AGENDA
PLANNING AND ZONING COMMISSION MEETING
CITY OF CREVE COEUR, MISSOURI
TUESDAY, FEBRUARY 18, 2014
7:00 PM

A. Application #14-003: Site Development Plan Approval for the Danforth Plant Science Center Phase II Expansion

**APPLICATION TO PLANNING AND ZONING COMMISSION
#14-003 FOR SITE DEVELOPMENT PLAN APPROVAL FOR
DANFORTH PLANT SCIENCE CENTER PHASE II**

**APPLICATION TO PLANNING AND ZONING COMMISSION #14-004
FOR REZONING TO "D" SINGLE FAMILY RESIDENTIAL AND APPROVAL OF A
PRELIMINARY PLAT ACCORDING TO THE RESIDENTIAL DESIGN DEVELOPMENT
(RDD) PROCEDURE FOR THE CREEKSIDE AT MASON SUBDIVISION
FOR THE MEETING OF: Tuesday, February 18**

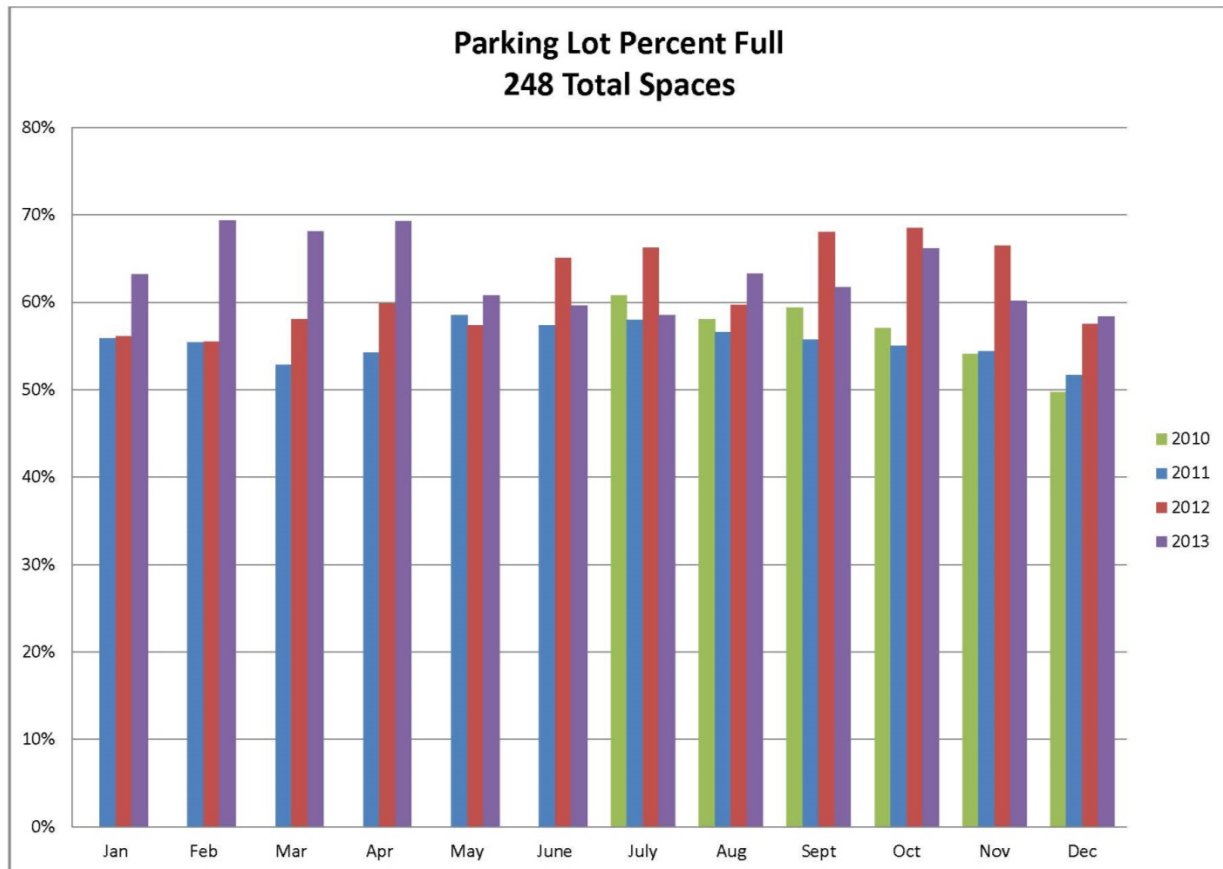
Howard Bittenmiller, Director of Facilities and Support Services for Danforth, has conducted daily parking lot saturation counts of the existing parking lot since July 2010 and has provided the table below as evidence. The data shows the site rarely exceeds 60% and has yet to exceed 70% saturation, thus the proposed construction should provide adequate parking for the development.

Job: **S1 - GL18-1-2-125A-CW-UNIV-SC**
 Type: **S2 - GL18-1-3-125LA-CW-UNIV-SC**
 Notes: **S3 - GL18-2-3-125LA-CW-UNIV-SC**

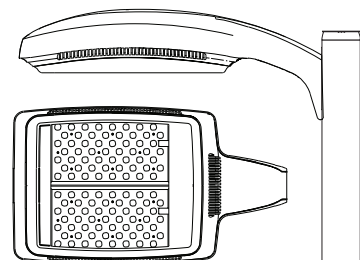
The Applicant submitted a photometric plan indicating that lighting will not be cast upon adjacent property or public right-of-way in compliance with Section 405.680. However, Staff is unclear if the proposed fixture is adequately shielded to comply with the regulations and, if it is not, a different fixture will need to be selected prior to issuance of a site improvement permit.

The proposed Phase II expansion meets with the applicable Zoning District regulations and the goals and objectives Comprehensive Plan, subject to the following conditions that all lighting shall meet with Section 405.680 of the Zoning Ordinance, and that any sidewalk along Olive Boulevard shall be a minimum of six feet wide if not detached from the road by a minimum of three feet of greenspace in compliance with the City's Pedestrian Plan.

Sheet Title: Landscape Plan
Sheet No.: L-1

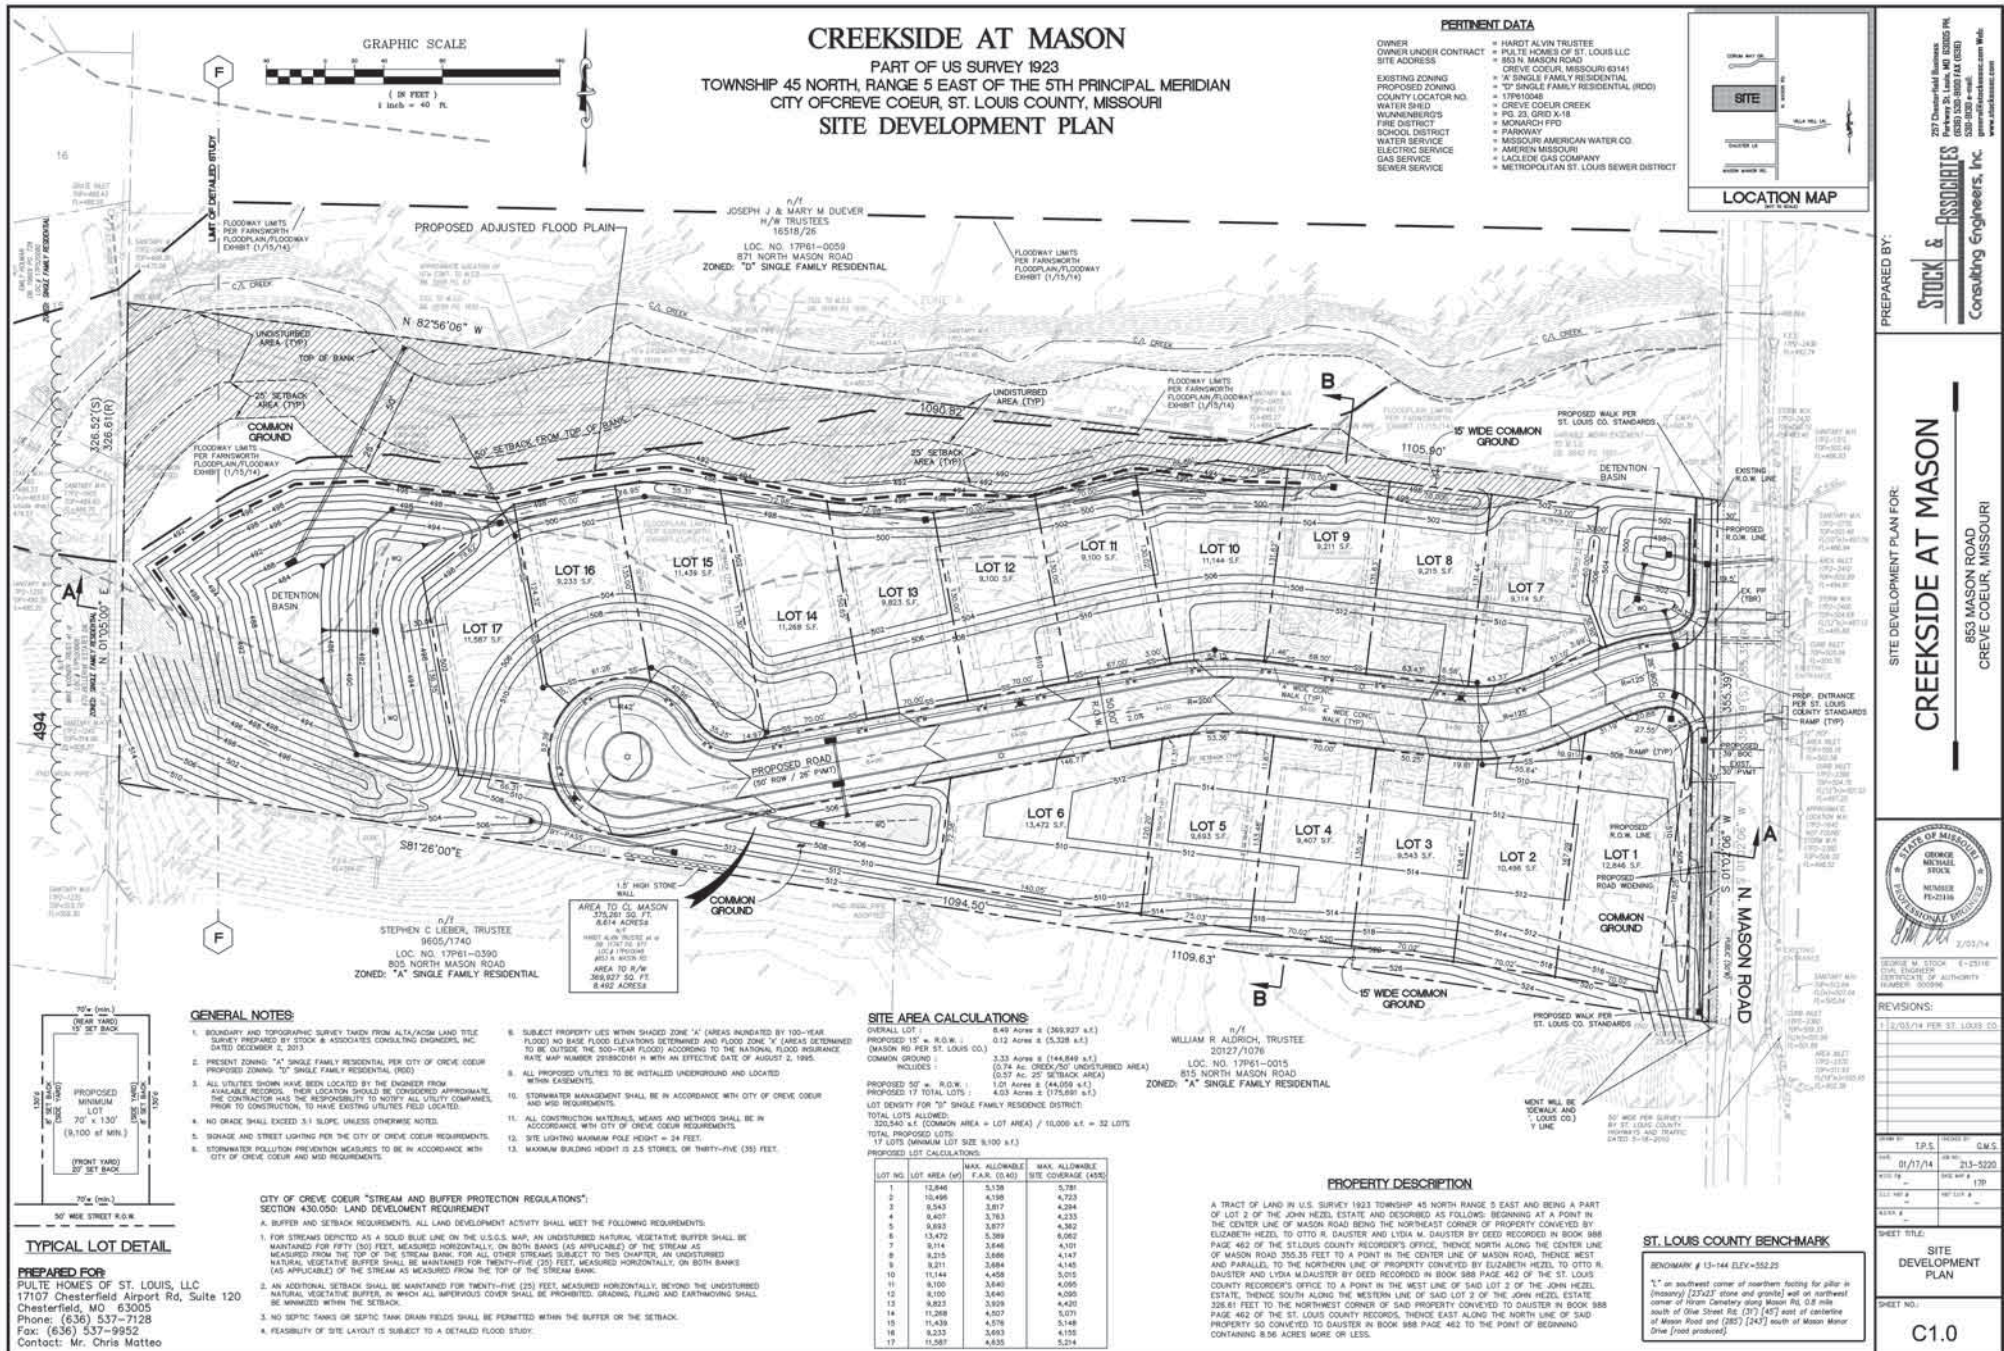
The Applicant has included a 15-foot buffer, as part of the common ground, along the south property line in addition to the stream protection along the east and north property lines. New trees have been included along the south and east property lines. The Landscape Plan indicates that the street trees provided are to be 40 feet on-center, where Section 410.300 of the Subdivision and Development of Land requires a minimum of one street tree for every 30 lineal feet or part thereof of street frontage. Therefore, Staff has included a condition that the Landscape Plan shall be revised to include the appropriate number of street trees for the Zoning Administrator's approval.

The Tree Preservation Plan submitted indicates that the property has approximately 1.9 acres of tree canopy and, if approved, 85.3% of this mass will be eliminated. As discussed above, the minimum standard is that 25% of the trees must be preserved, as required by the section below. Therefore Staff has included a condition that the Landscape Plan shall be revised to meet with Section 410.320 of the Subdivision and Land Development Standards

- The Landscape Plan shall be revised to include adding a minimum of one street tree for every 30 lineal feet or part thereof of street frontage, as required in Sections 410.300 and 410.320 of the Subdivision and Land Development Standards.

- The grading plan shall be revised to reduce the impact on existing tree masses to the extent that a minimum of 25% of the existing tree mass shall be preserved, subject to Zoning Administrator approval.
